MEMO – BOILERS REVIEW RECAP

Submitted To: ABM

Revision 2, November 10, 2022

Project: Nueces County Performance Contract

M7.7.2

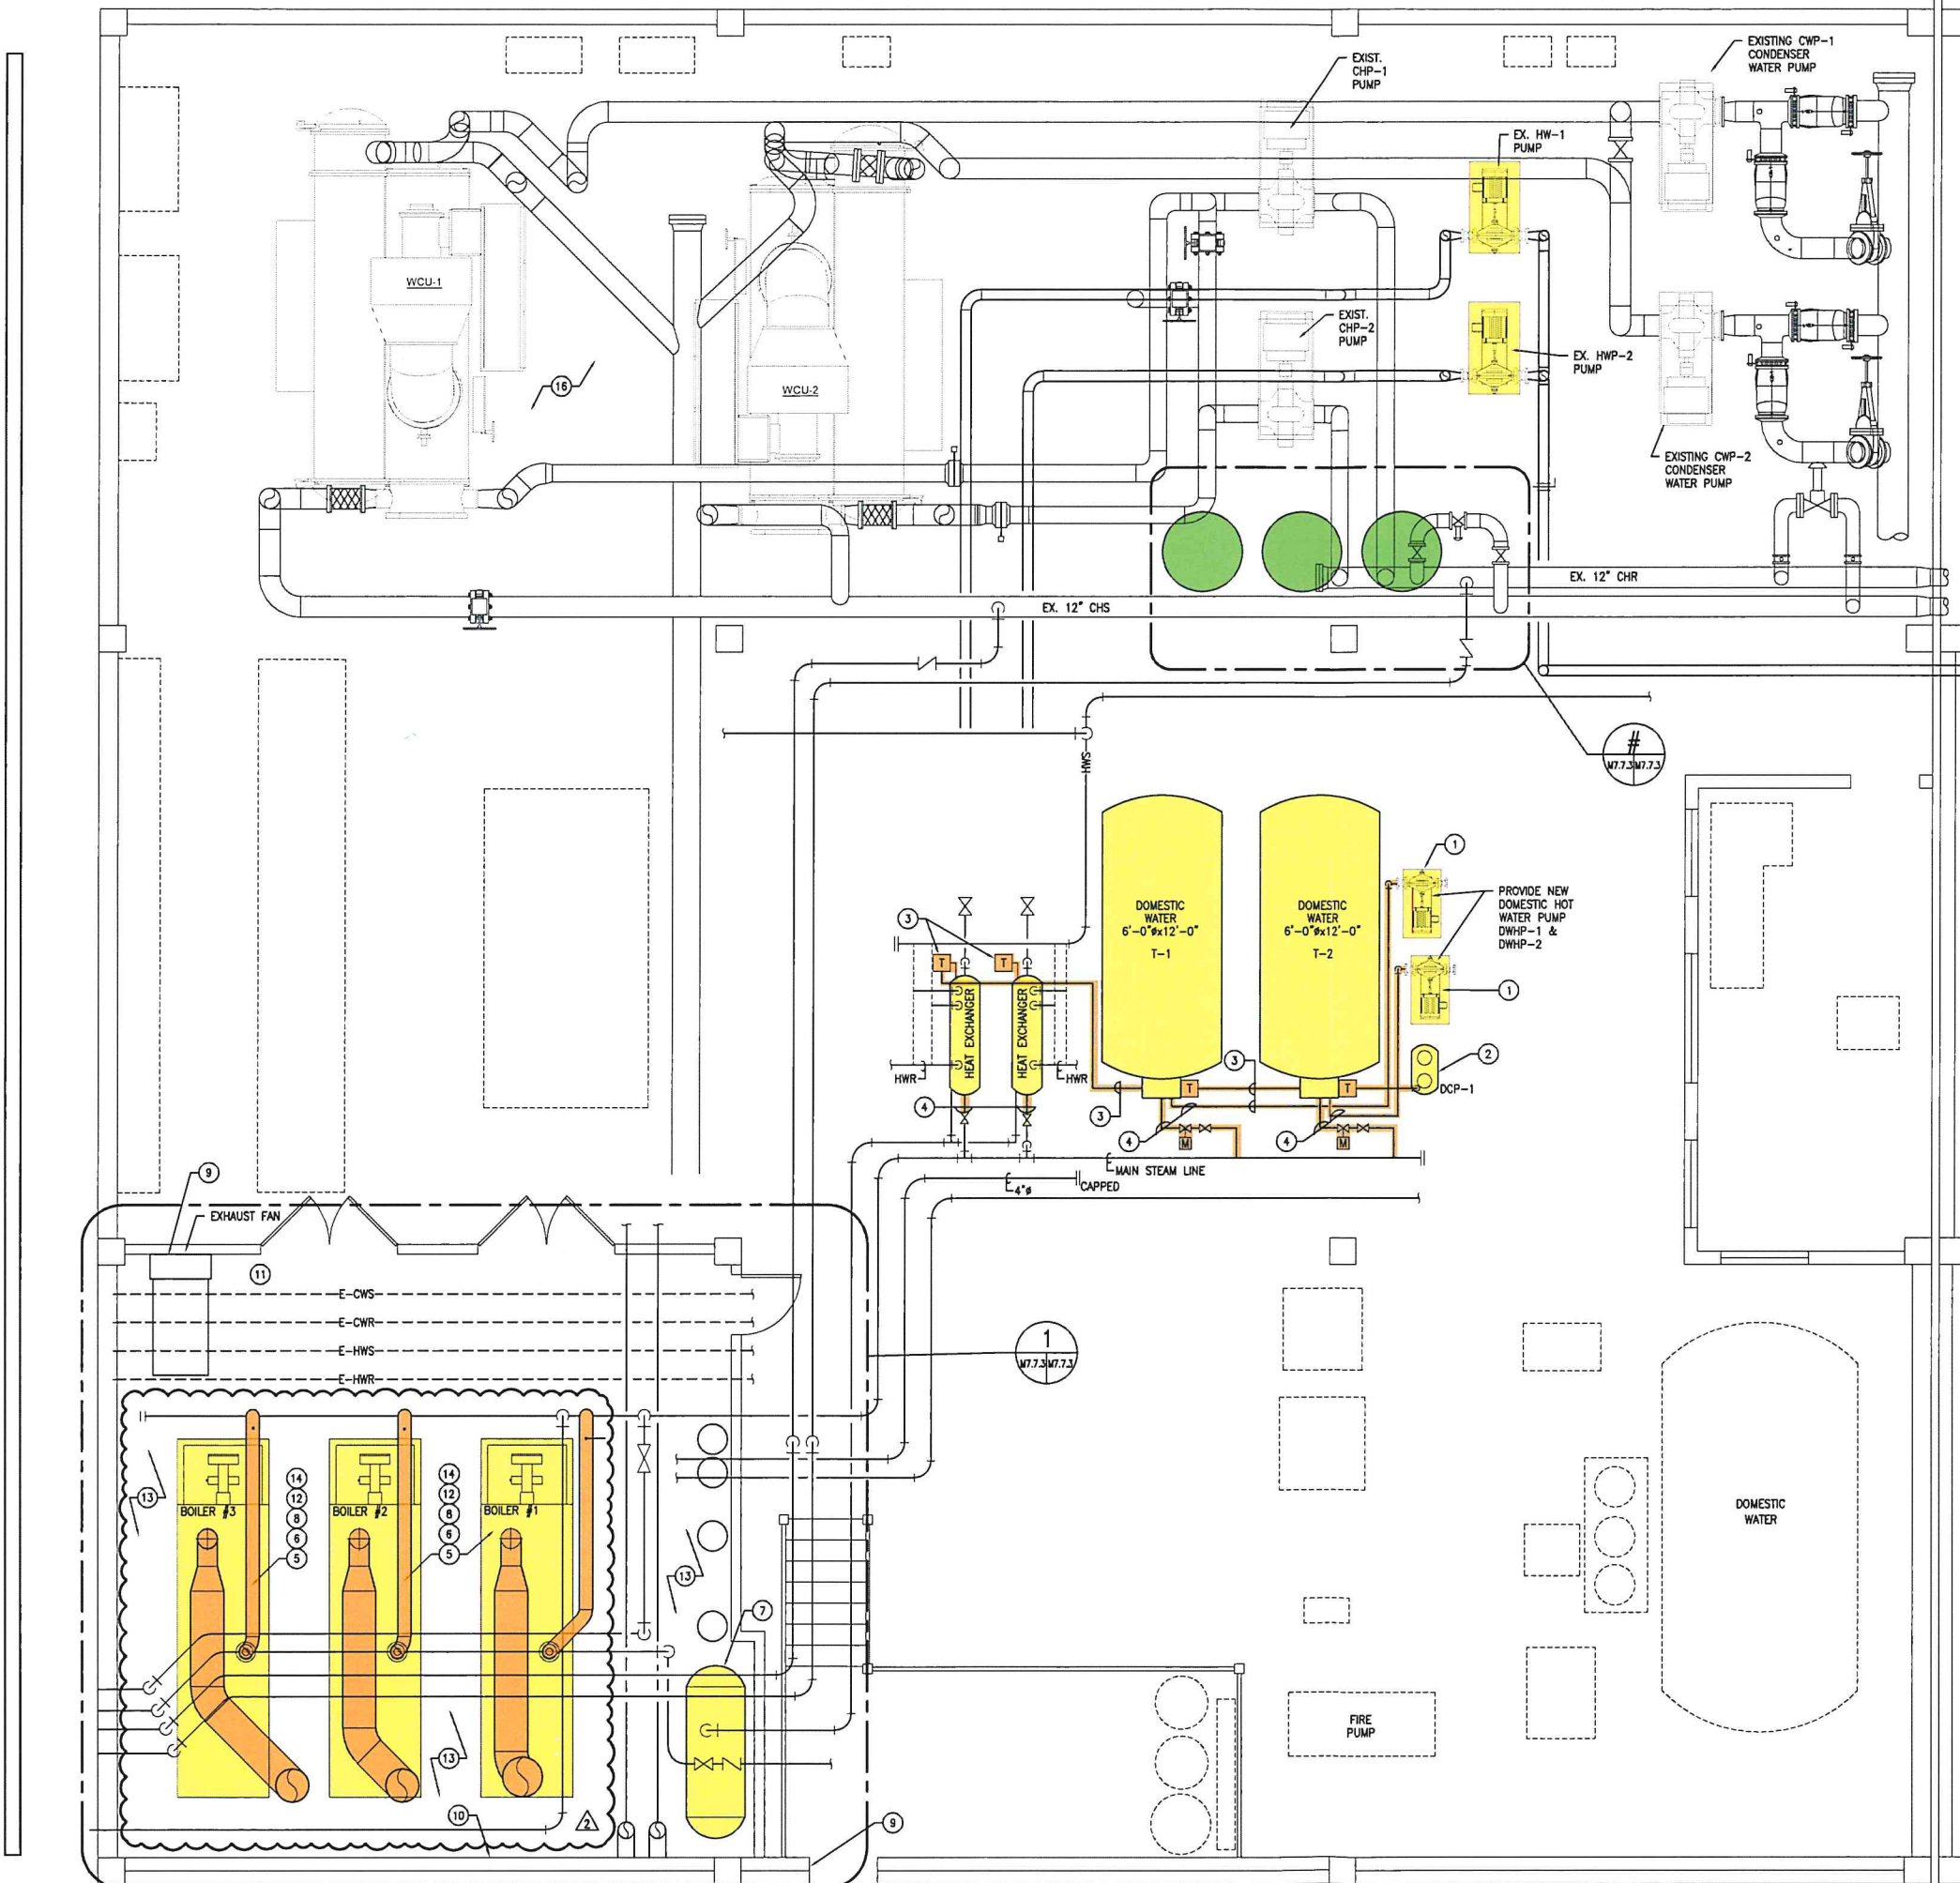
DDC control which must be installed. **A detailed DDC Diagram is attached to illustrate work noted on Sheet M7.7.2, #8.**

- I. Additional piping work is required on the steam line system at the domestic water tanks shown on sheet M7.7.2. Drawing clearly indicates that control and isolation valves along with vertical piping connections to the steam main should be replaced as part of the project. This work is not done. Refer to Keynote number four on the above sheet.

PROJECT #: 2004
DATE: 7/7/2021
Drawn: C. CHRISTENSEN
Checked: R. WHEATON
Issued: R. WHEATON
REVISIONS:
1 - FOR CONSTRUCTION
Sheet Number:
M7.7.5

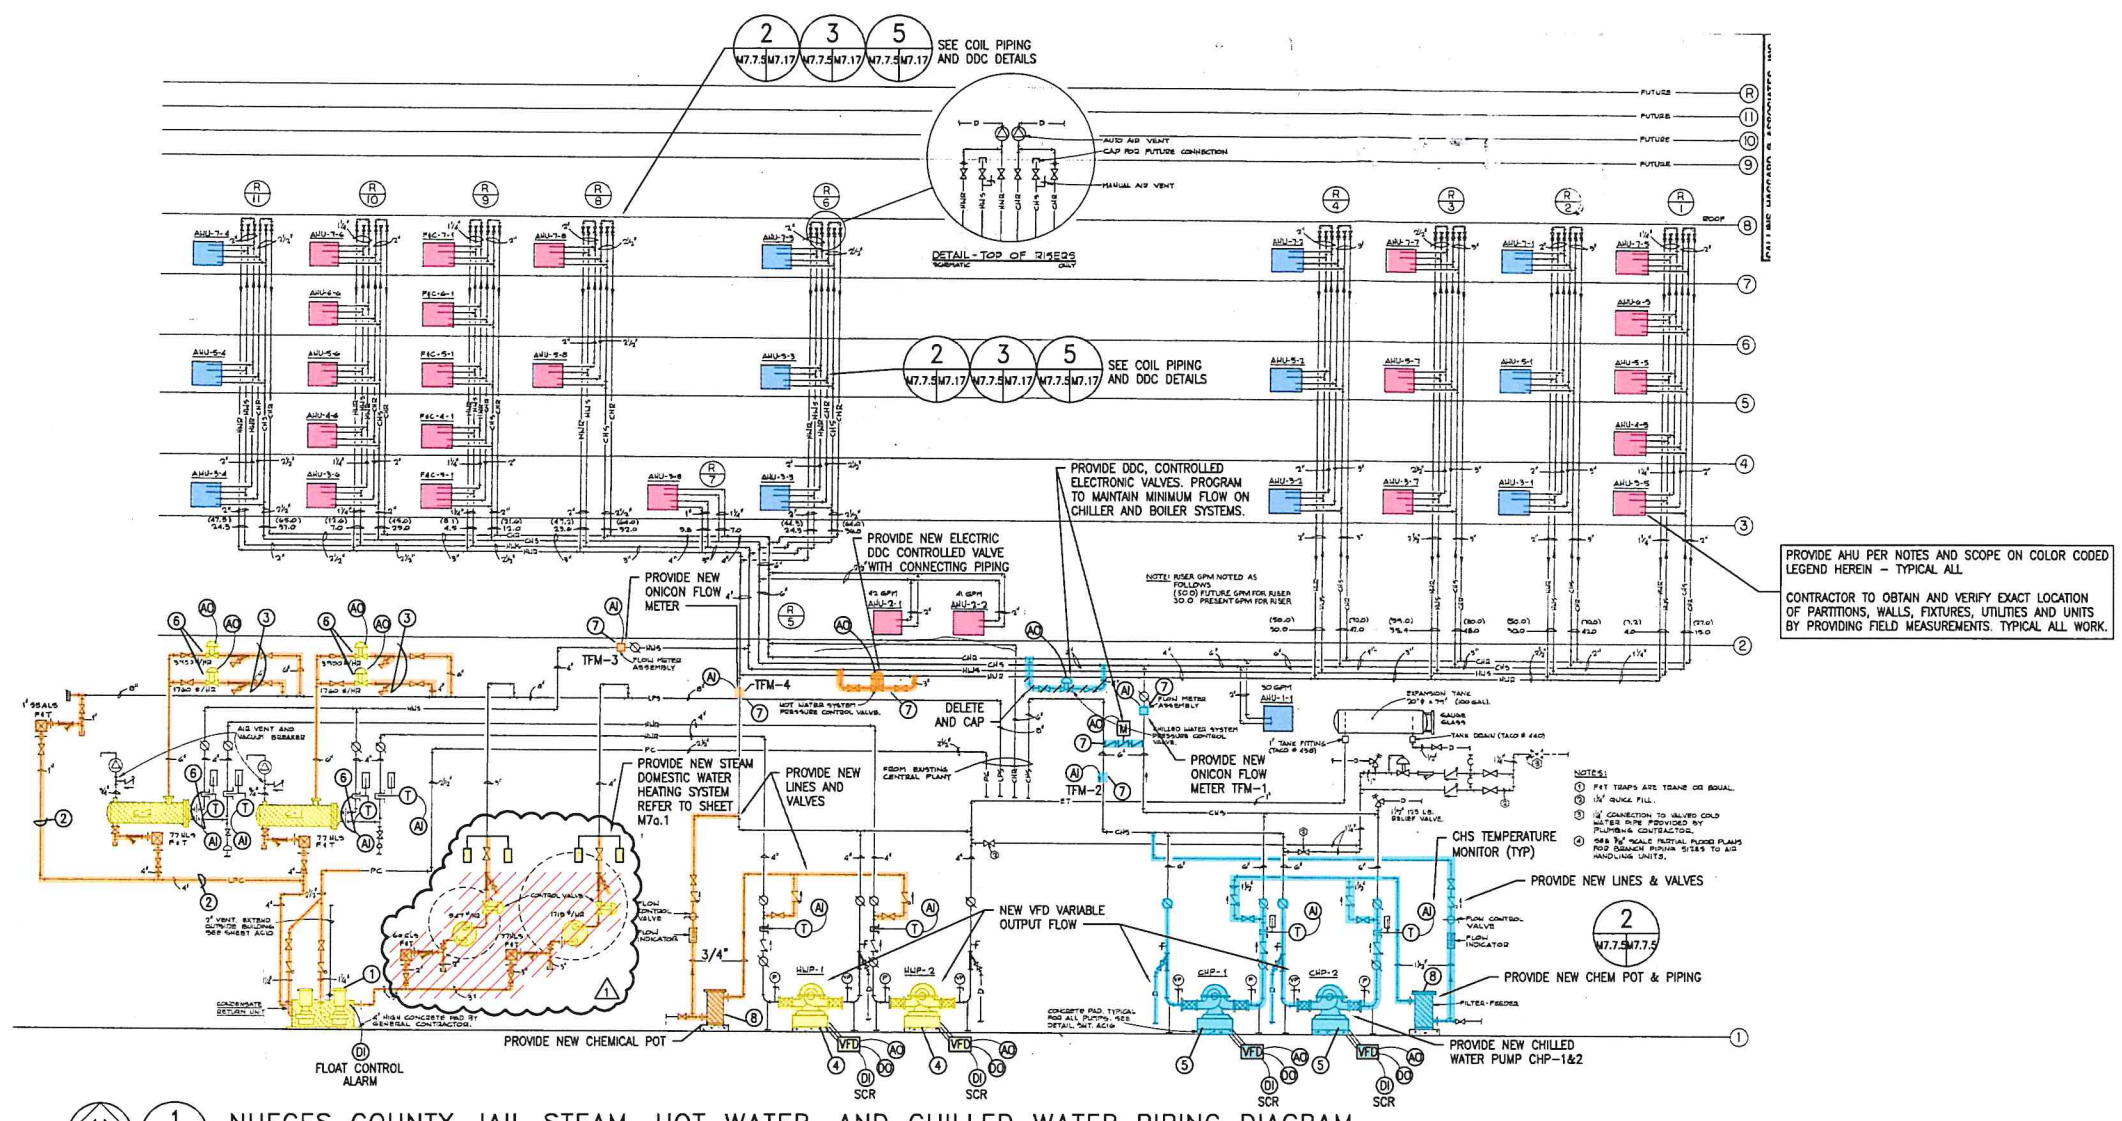
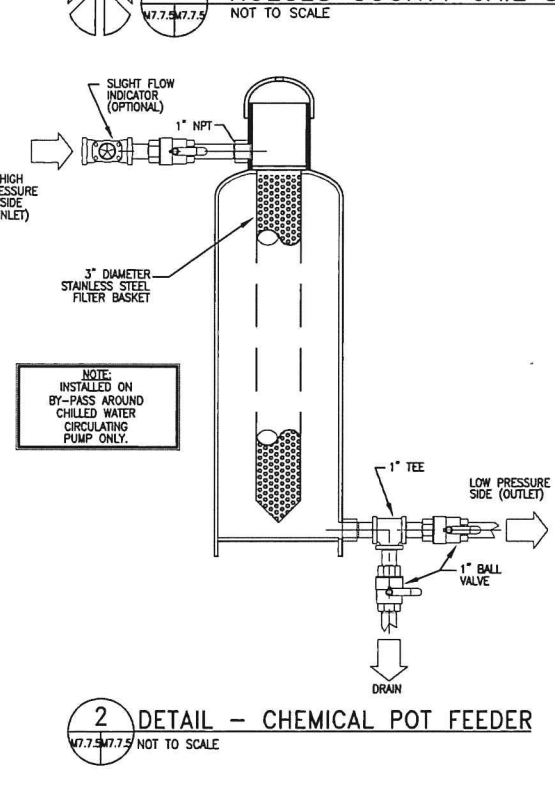
7. Steam to Hot Water Heat Exchanger
- a. Steam control valves are required to be upgraded refer to drawing M7.7.5, pneumatic control valves are still in place, piping upgrade around the heat exchangers as part of project.

- b. Steam traps at the same heat exchangers are existing units drawing requires upgrade refer to keynotes sheet M7.7.5

13. Room 120 controls: drawing sheet M7.7.5, this drawing specifically outlines DDC control for both the hot and chilled water pumps that were upgraded inside of the jail system. None of these DDC systems appear to be connected or operating based on input received during phone conference calls on September 26th. All pump controls and bypass system controls need to be reviewed and modified as necessary. Additionally, as documented in previous punch list reviews the pneumatic valves on the building heating hot water supply heat exchangers have not been upgraded to electronic DDC control systems. Items noted here are required to support the dehumidification system and all 2-way valves on both hot and chilled water at the jail air handlers.

DDC BOILER MONITORING
TWO BOILER "ON" - LEAD LAG

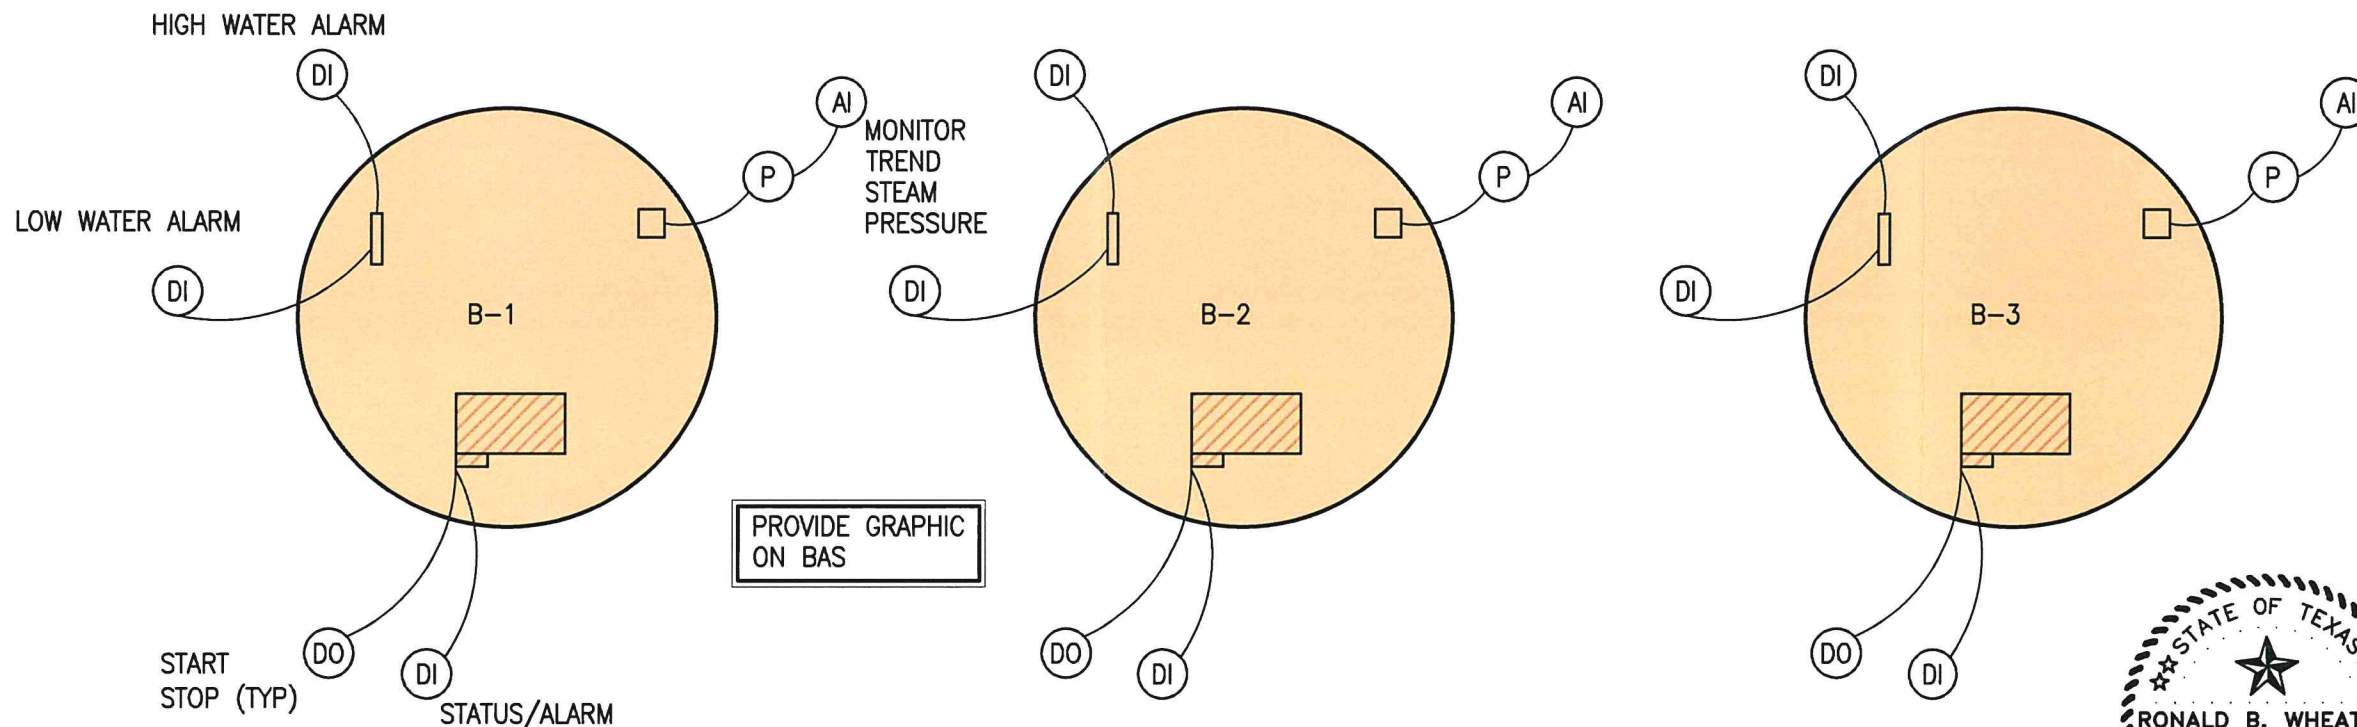
8. Boiler operation was observed. All boilers were maintaining water levels and all three boilers were active and operating. There is still no DDC control connected to the boiler systems, which has been the subject of multiple review memos at this point. Given that, there is no way to automatically lead-lag the boilers to decrease the amount or frequency rotation time. This also substantially affects condensate accumulation due to the fact that some boilers may be in a lag mode for multiple days. Notes on drawings required BAS-
